# Local Planning Panel

38-44 Mountain Street, Ultimo

D/2020/1288/A

# Proposal

Approved Height

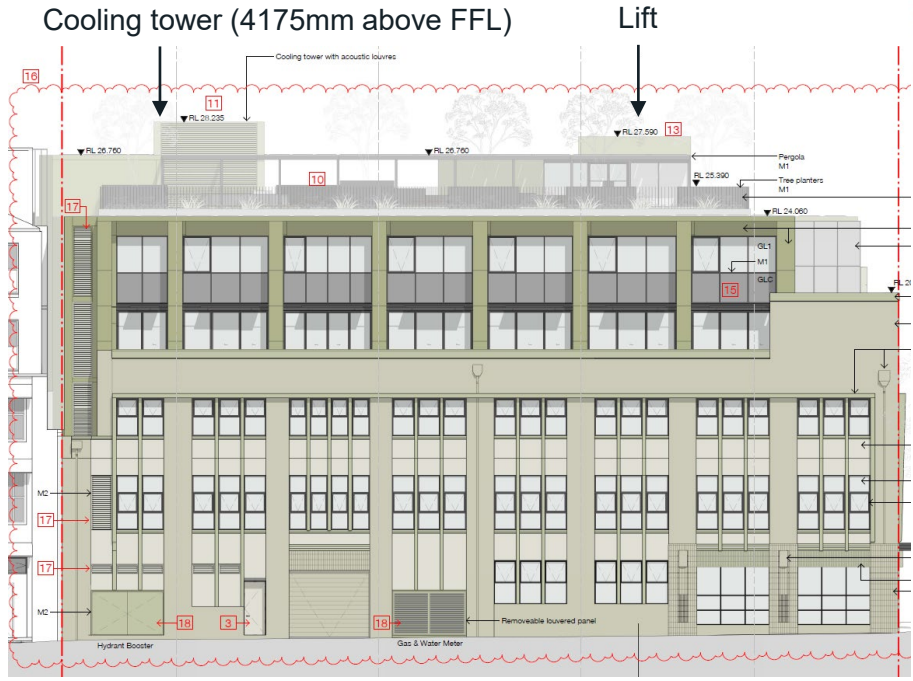
- cooling tower creates a total height exceedance of 25.1% against height standard (6.8% increase upon approved height)
- lift overrun proposed to be increased by 120mm for lift mechanism
- the cooling tower will enable compliance with a condition of consent regarding NABERs rating, and the height exceedances are not likely to generate any environmental impacts
